Planning Commission Staff Report

Petition: **P.Z. 06-2022 17733 N. Outer Forty Road (Gateway Studios, LLC)**: A request for a zoning map amendment from a “M3” Planned Industrial District to a “PC” Planned Commercial District for 34.02 acres located on the north side of Outer 40 Road (16V320056).

Re: PZ 06-2022 (17733 N. Outer 40 Road) – Response Letter
(Stock Project No. 221-7165)

Figure 4: Preliminary Development Plan

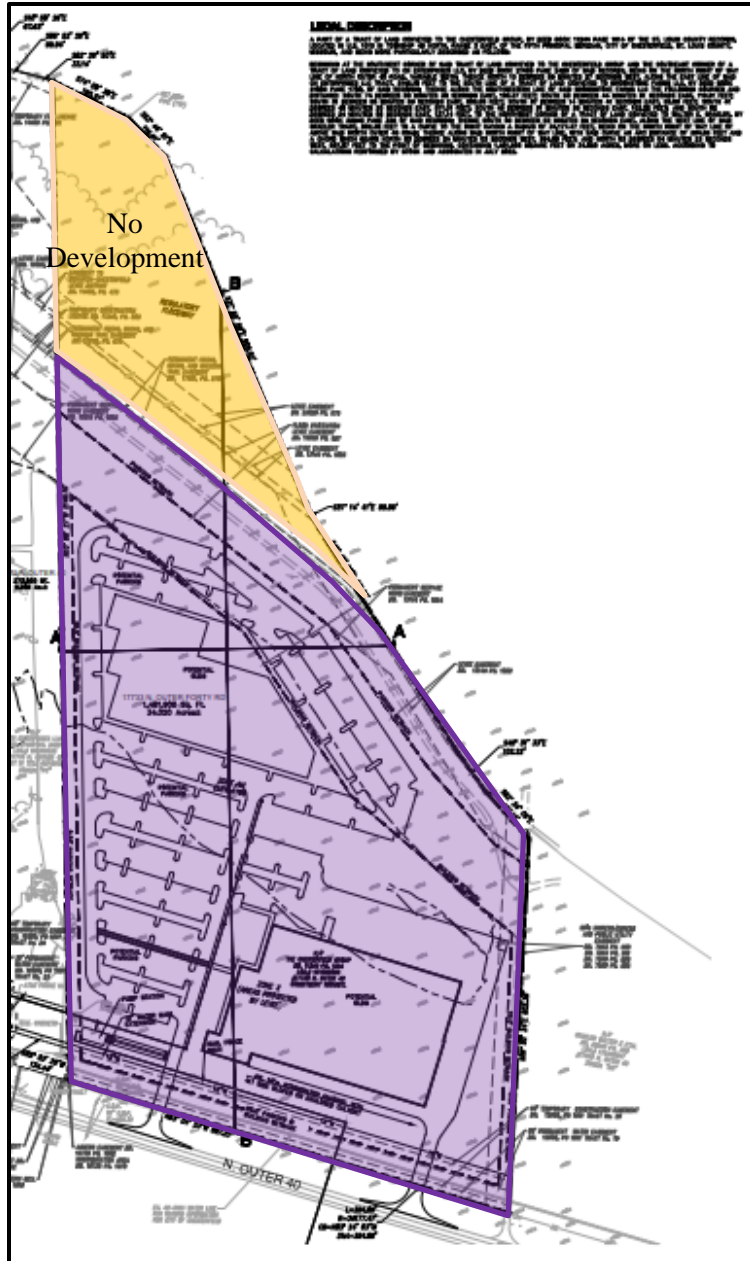
Concern was raised regarding any future restrictions on the public access to the Levee trail that runs through the subject site. Provide information on how the development team will be addressing the above concern to provide future public access to the Levee trail.

Response: This Development "Does Not" intend to restrict the Public Access to the Levee Trail. A 50' ft wide Ingress/Egress utility easement exists on the east side of the property.

DRAWN BY: K.S.G. CHECKED BY: G.M.S.
DATE: 06/09/2022 JOB NO: 2022-7165
SCALE: 1/8" = 1'-0" DATE: 06/09/2022
ELEC. SET # 16V
M.D.A.R. # MO-00
SHEET TITLE: PRELIMINARY DEVELOPMENT PLAN
SHEET NO.: PDP-1.0

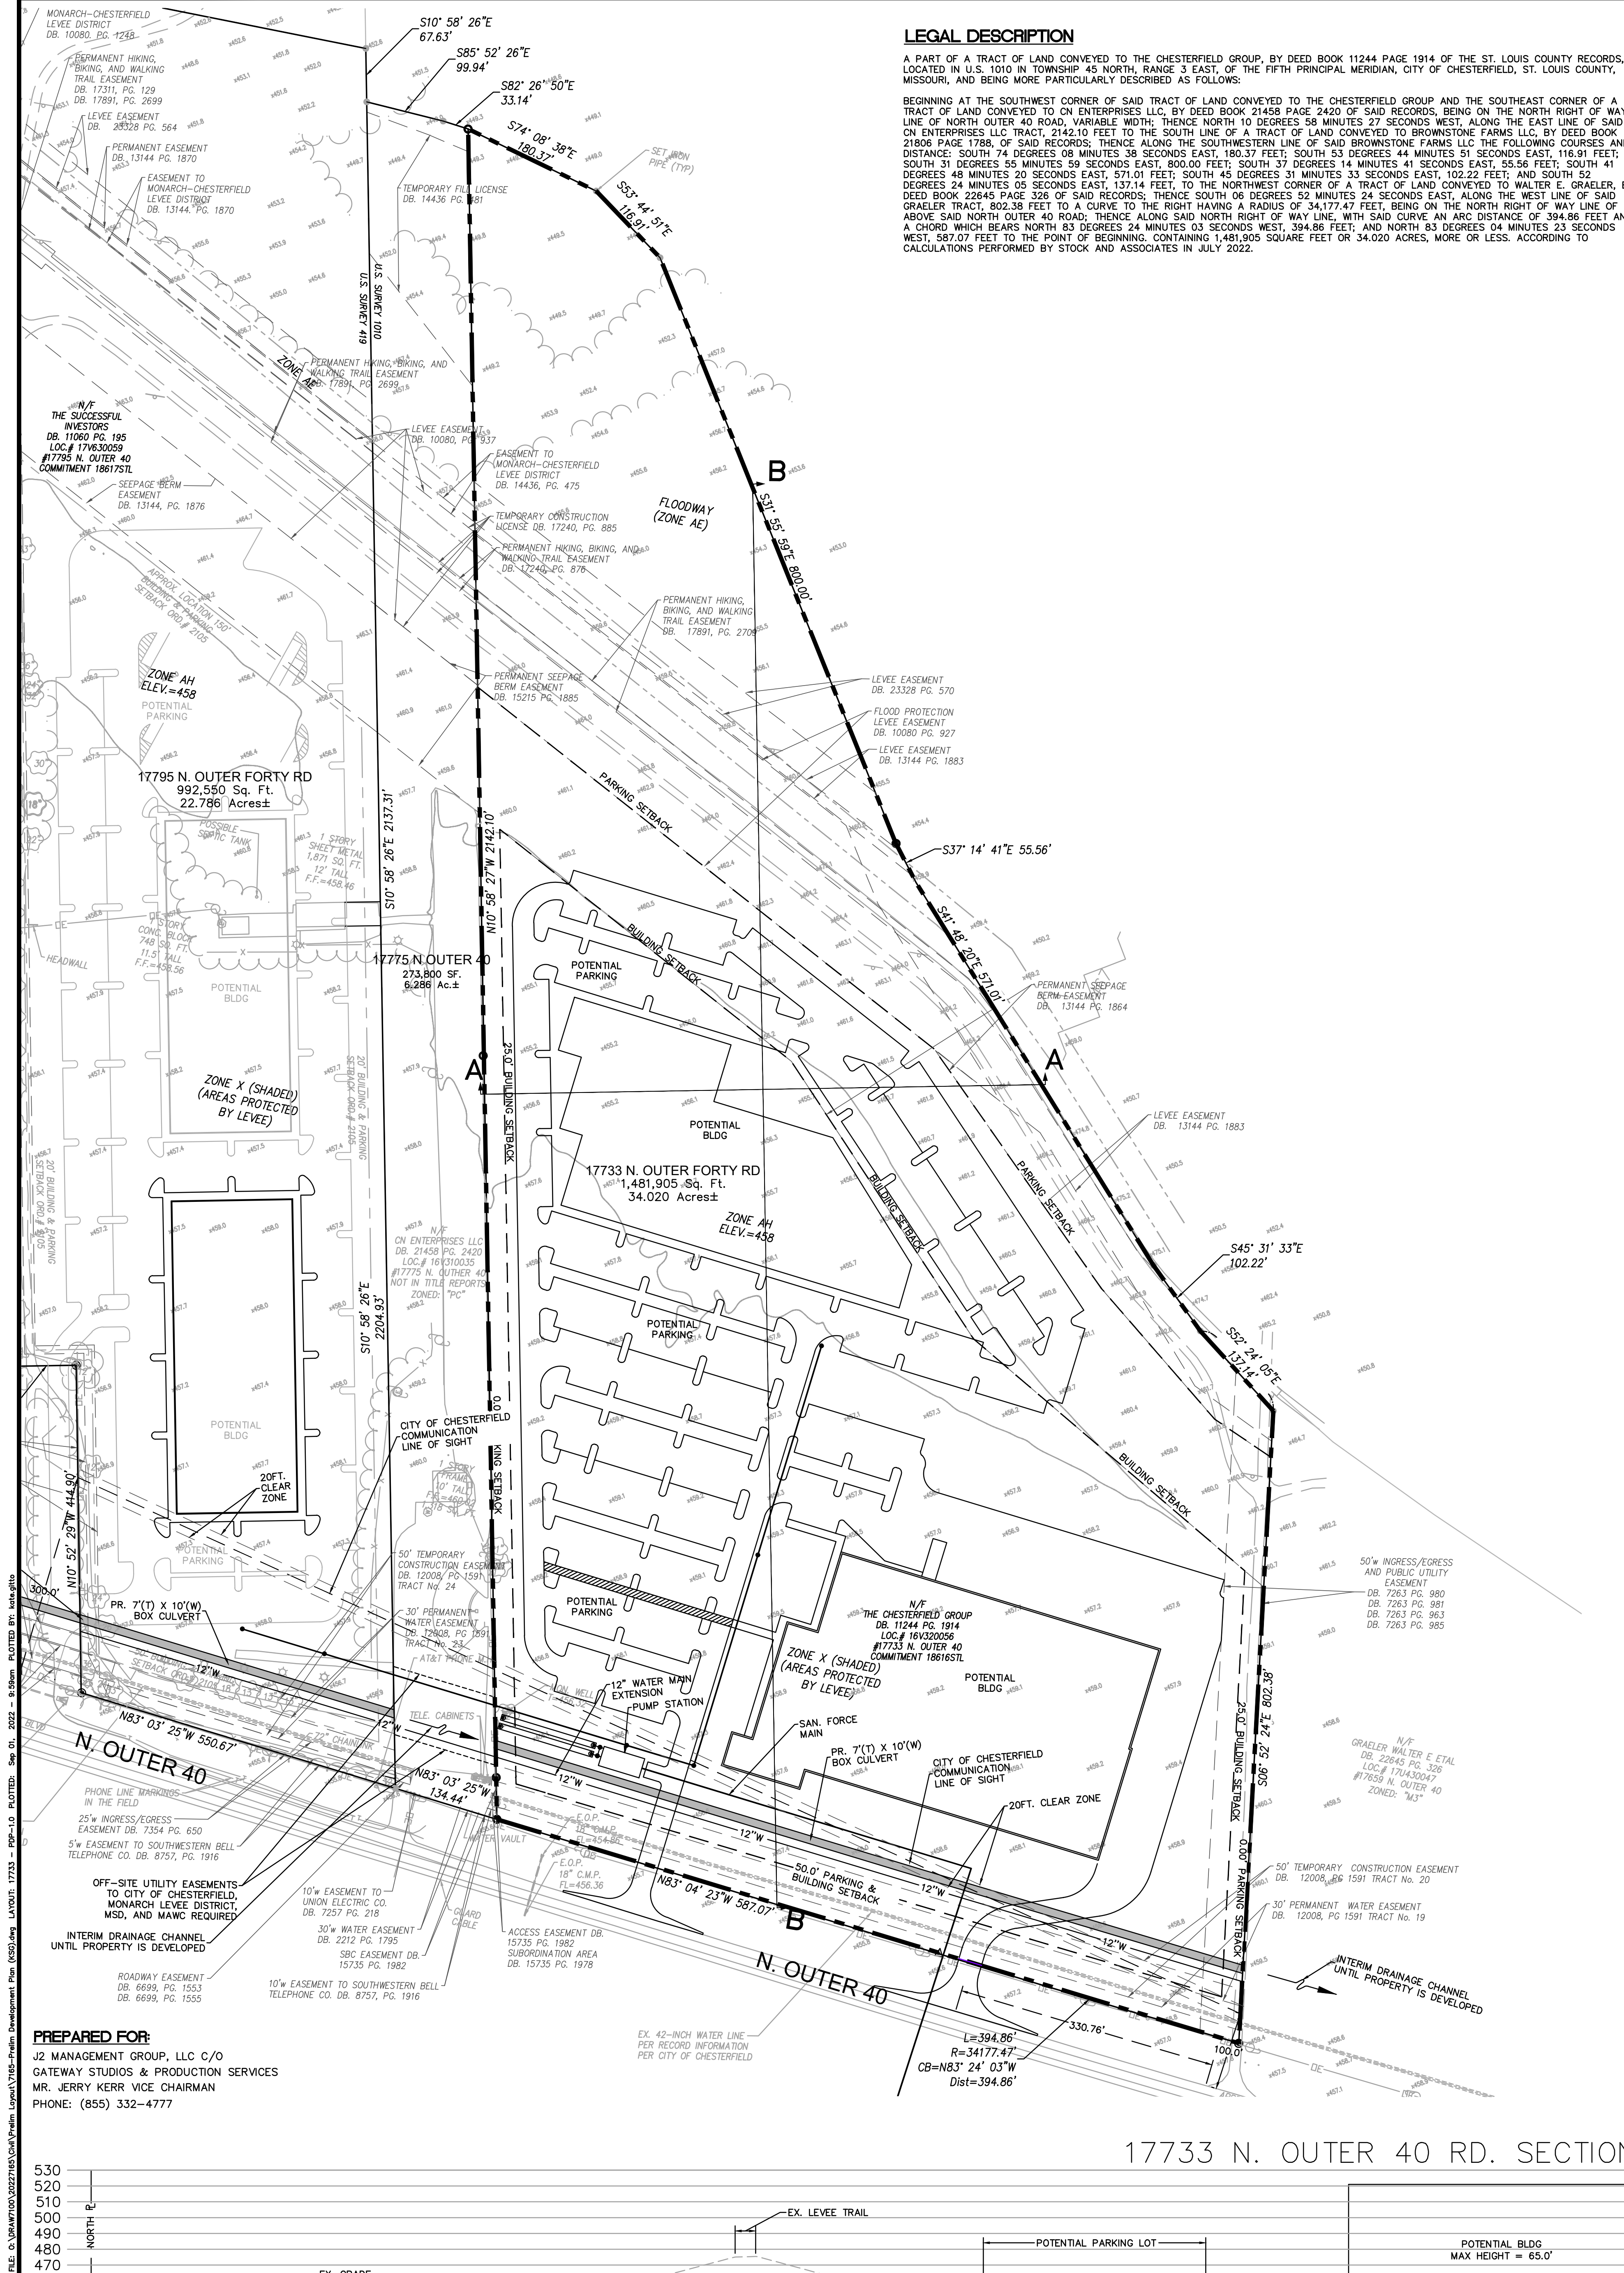
1. The distance between the existing gravel access drive along the eastern property line and the eastern proposed entrance does not meet the City's access management requirements. The required distance between these access points is 300 feet Please revise the plan as necessary.

2. If the location of the existing drive along the eastern property line is altered to meet the City's access management requirements, then new/revised access easements may be necessary. If this is the case, the preliminary plan should be revised to depict the necessary easements.

3. For the City of Chesterfield communication line of sight, a 20-foot-wide clear zone centered on the alignment shown is required. Anything located in the clear zone would need to be under 30 feet in height. The current preliminary plan only depicts a 10-foot-wide clear zone. Please revise the plan to provide a 20-foot-wide clear zone. As always, we appreciate your continued assistance and support for this project. Should you have any question or comments, please feel free to call.

Response: We have shifted the proposed access driveway to North Outer 40 to provide 300-feet from the existing gravel driveway located near the east property line.

Response: We do not intend to relocate the existing gravel driveway located adjacent to the East Property line.

Response: We have revised the Preliminary Development Plan to comply.
